Office Action Summary	Application No.	Applicant(s)	
	10/719,019	KIM, SUNG-SIK	
	Examiner	Art Unit	
	Lucy P. Chien	2871

3. Claim 1-14,17,18 are rejected under 35 U.S.C. 103(a) as being unpatentable over Popovich et al., (Popovich), USPAT 6,525,847 in view of Yasuda et al., (Yasuda), EP 0 540 137 A1 (provided by the applicant).

FIG. 20

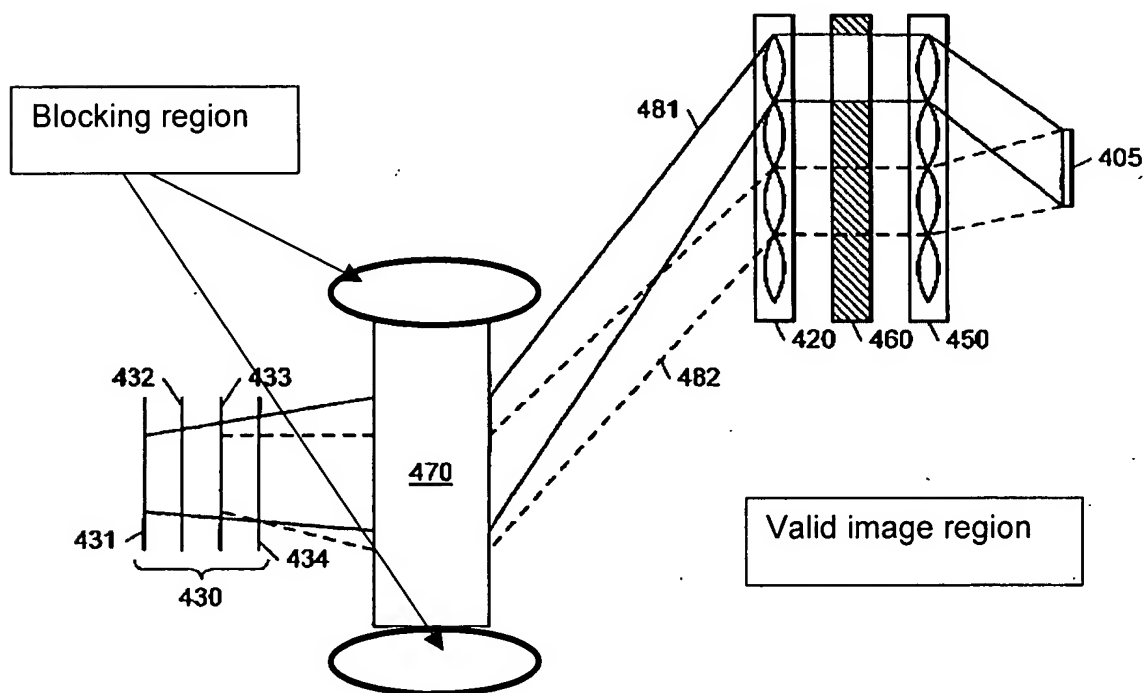
As to claims 3-4 and 10-12, Popovich discloses the display apparatus as recited above having a switching panel (470) with valid image display region to transmit light and a selective blocking region to block light (see circled/label areas in fig. 20 reproduced below for convenience).

Furthermore, Popovich discloses that the valid image display region can be adjusted to any size (col. 25, lines 35-59) and satisfies the formulaic expressions of

claims 10-12 where Popovich discusses adjusting size and viewing distances according to the Rayleigh two-point criteria (col. 25, lines 35-39).
